**RE: Lot 11 Block 4 Unit 22 SAD 228  
6409 Canavio Rd. NW  
Volcano Cliffs Subdivision  
Grading and Drainage Plan  
Engineers Stamp Date 1/25/2022 (D10D003D11)  
Pad Certification Date: 3/24/2022**

Based upon the information provided in your submittal received 3/28/2022, this plan cannot be approved for Building Permit until the following comments are addressed..

ENGINEER'S SEAL  DAVID SOULE P.E. #14522	LOT 3 BLK 12 UN 24 VC 6508 JADE DRIVE	DRAWN BY DEM
	GRADING AND DRAINAGE PLAN	DATE 11-16-21
 Rio Grande Engineering P.O. BOX 53924 ALBUQUERQUE, NM 87199 (505) 321-9099		6508 Jade Dr. DWG
		SHEET # C1
		JOB #

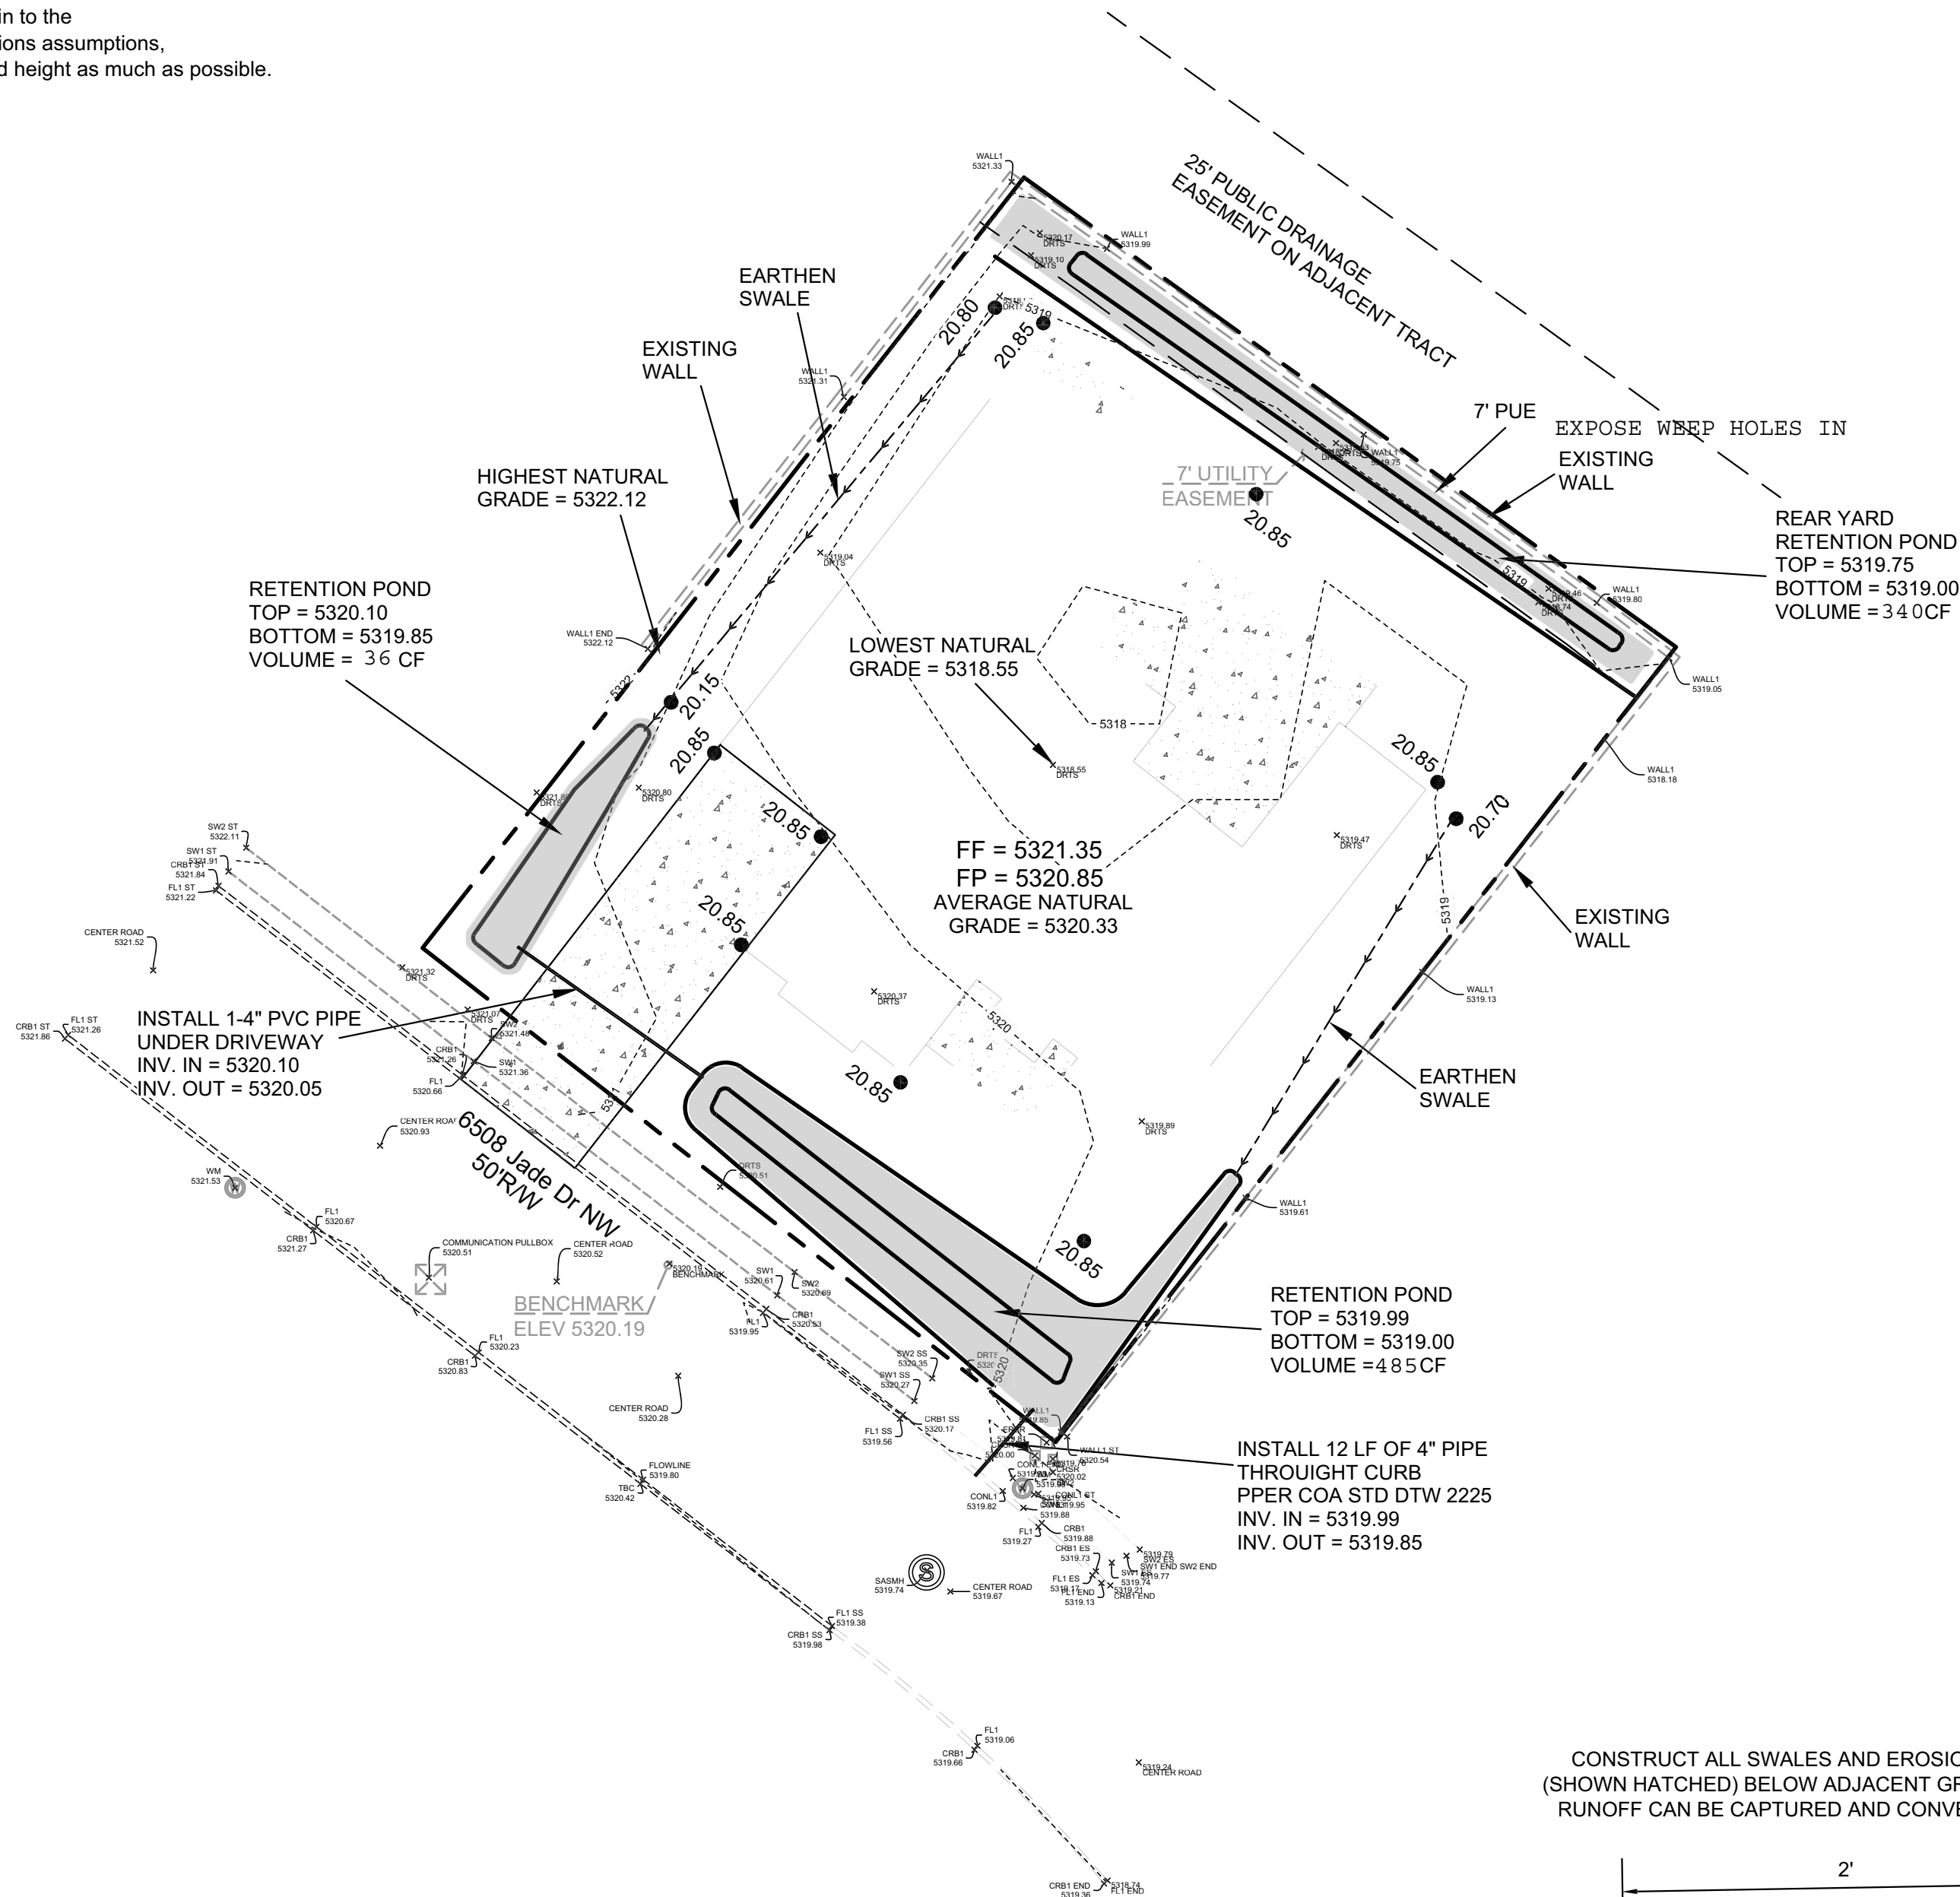
Due to the height restrictions in SAD 228, the finished pad cannot be higher than 1 foot above the curb height, unless there are extenuating circumstances which are called out on the plans in the notes section. Please revise the FP for this building.
